Proposed Changes
Sector Plan & Zoning Ordinance Maps
Draft 2/4/22

Proposed Map Changes- Block Key Map (Map 2.2)

Draft 2/4/22

Proposed Map Changes- Public Open Space (Map 2.9)

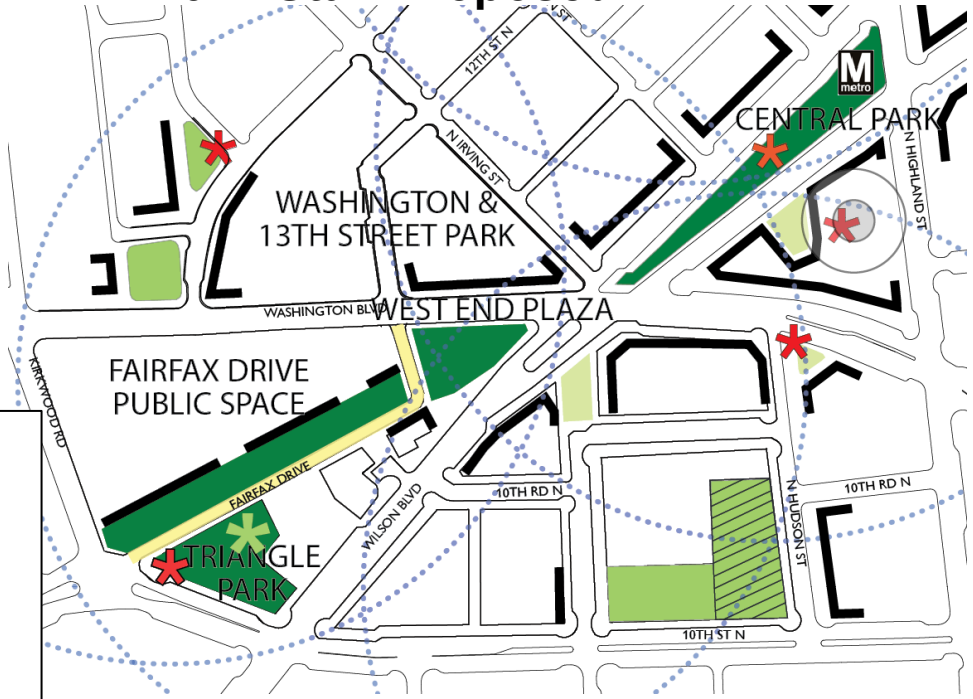
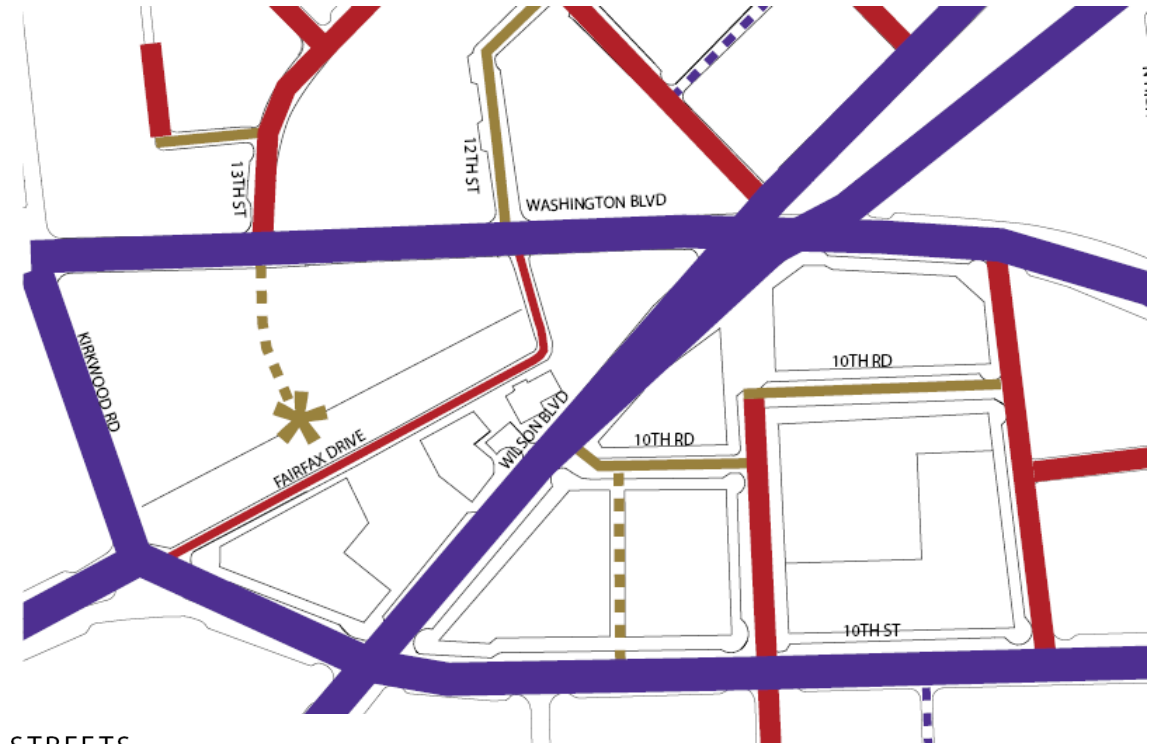
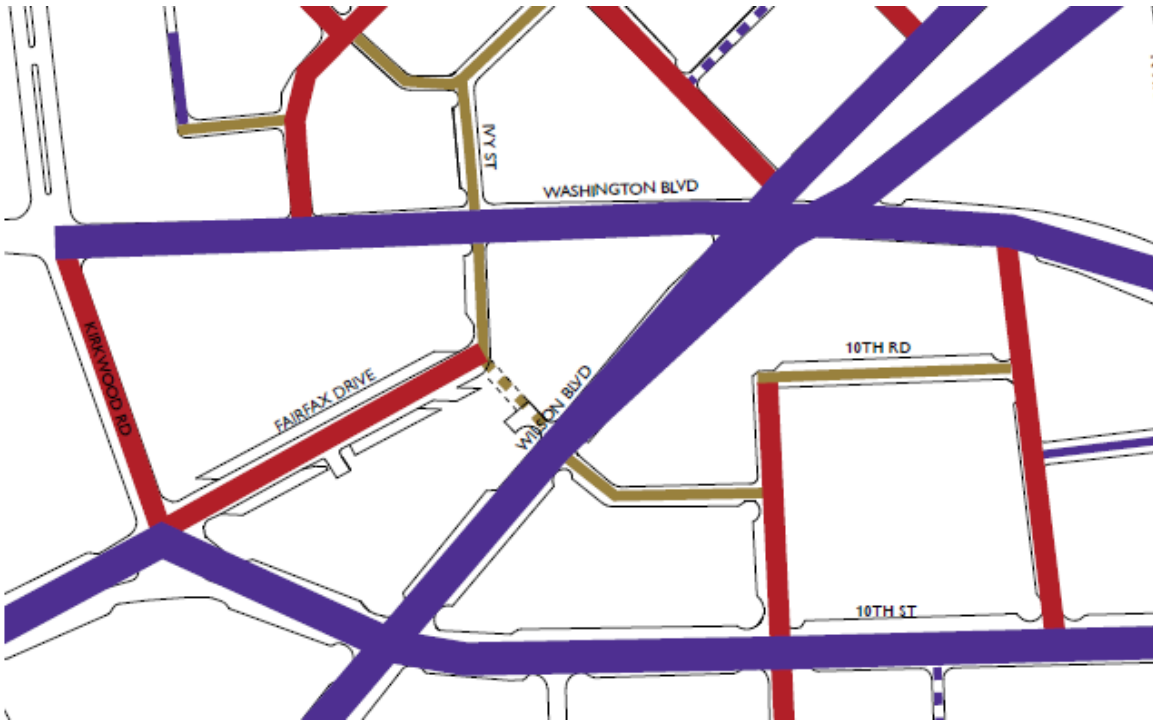
- Add Shared Street to legend for Fairfax Dr
- * Land acquisition required to achieve expansion of Triangle Park

Map 2.13

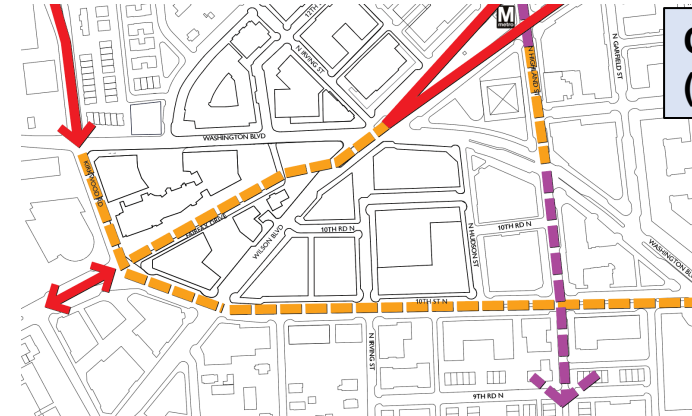
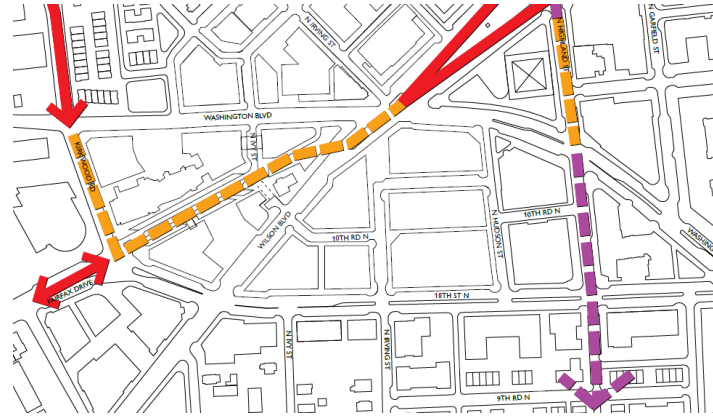
- Add Enhanced Bicycle Facility on 10th St. N. per MTP Bike Element
- Revised legend text

Map 3.4

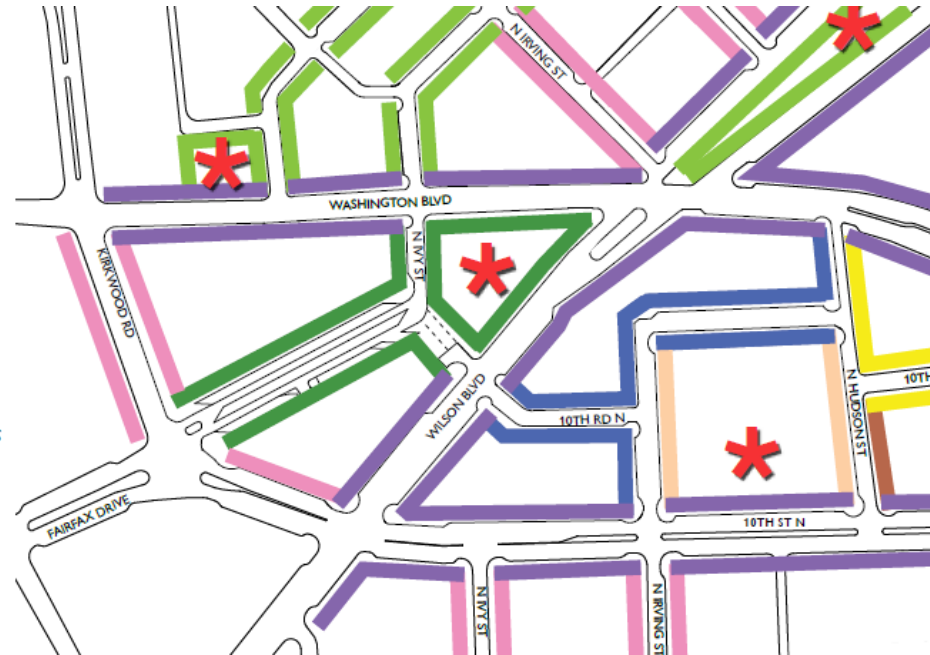
- Remove map
- Allow flexibility in species selection in coordination with County Urban Forester
- Make reference to the County Recommended Tree List
